TISBURY: PROPOSED WAITING RESTRICTIONS
RECOMMENDATIONS FOR AMENDMENTS TO PROPOSALS

Area	Decision
Vicarage Road	Implement as Advertised
The Square/High Street	Implement as Advertised
Upper High Street	Implement the proposals with amendments

Upper High Street

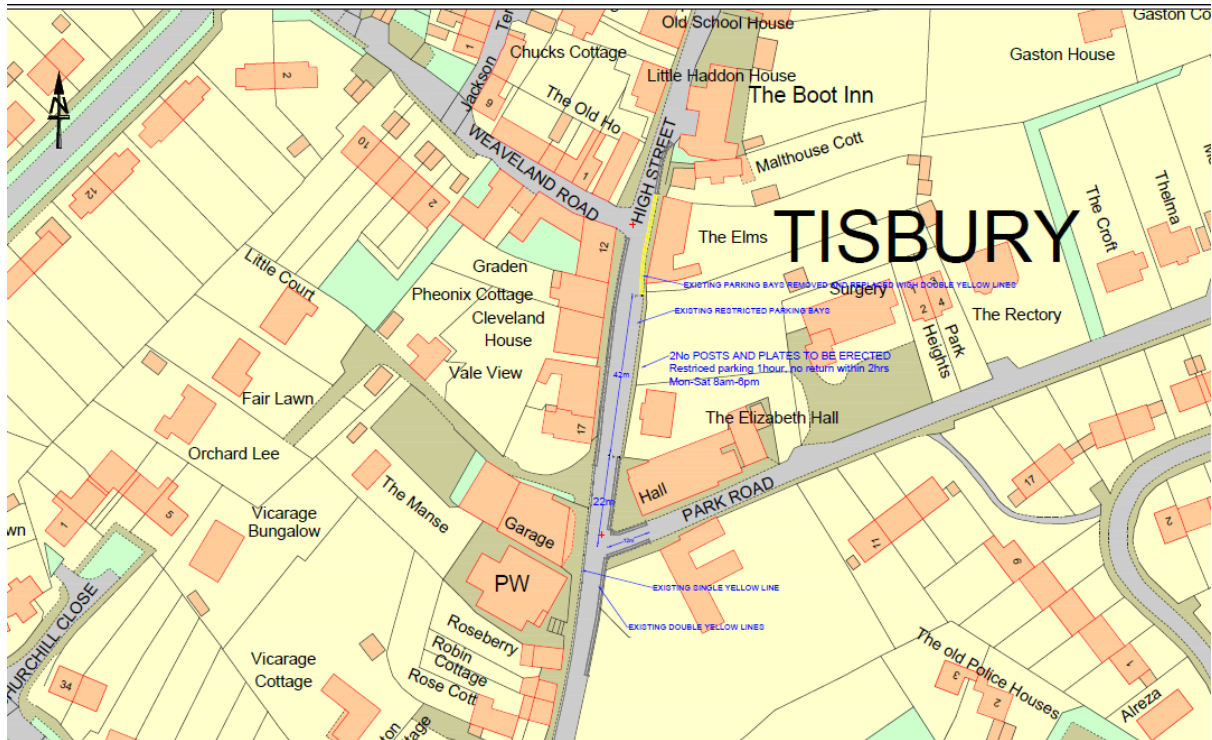
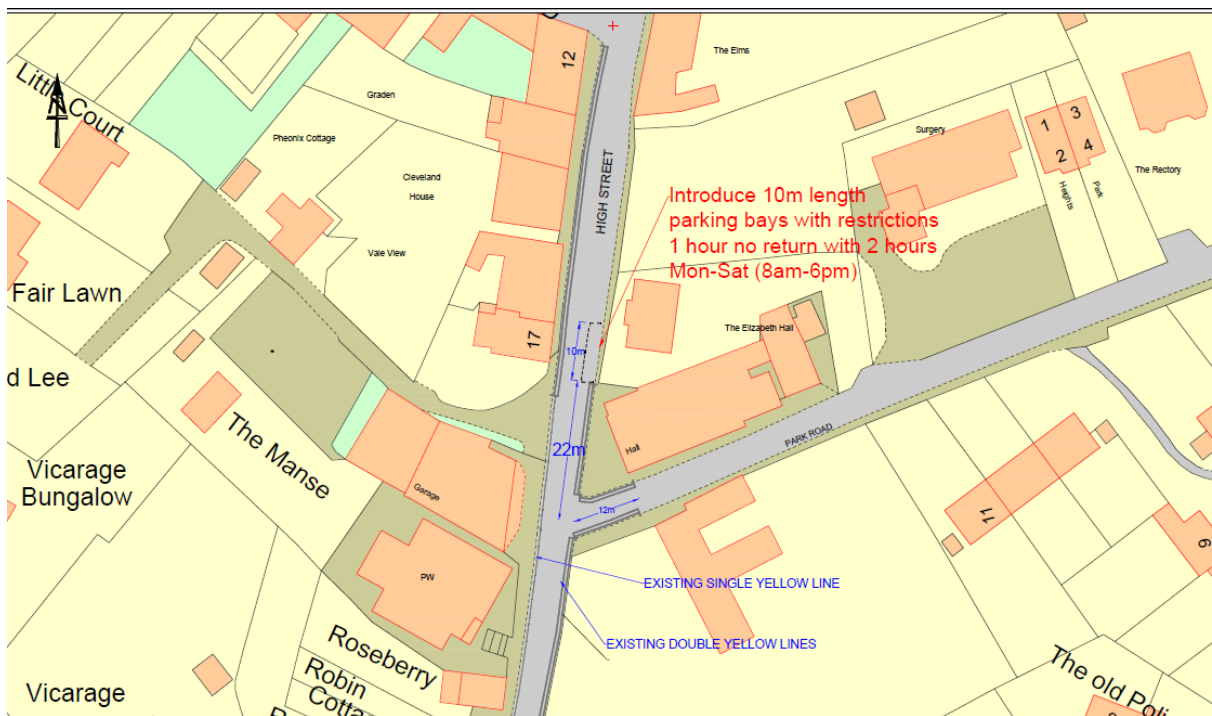
Following the consultation and the comments received it was considered appropriate to alter the proposal for Upper High Street by revoking the existing restricted parking bays on the east side of

Upper High Street, from a point 22 metres north of its junction with Park Round to a point 64 metres north of its junction with the its junction with Park Road. Install two new restricted parking bays (1hr between 8am to 6pm) to be installed from a point 22 metres north of Park Road to a point 32 metres north of its junction with Park Road
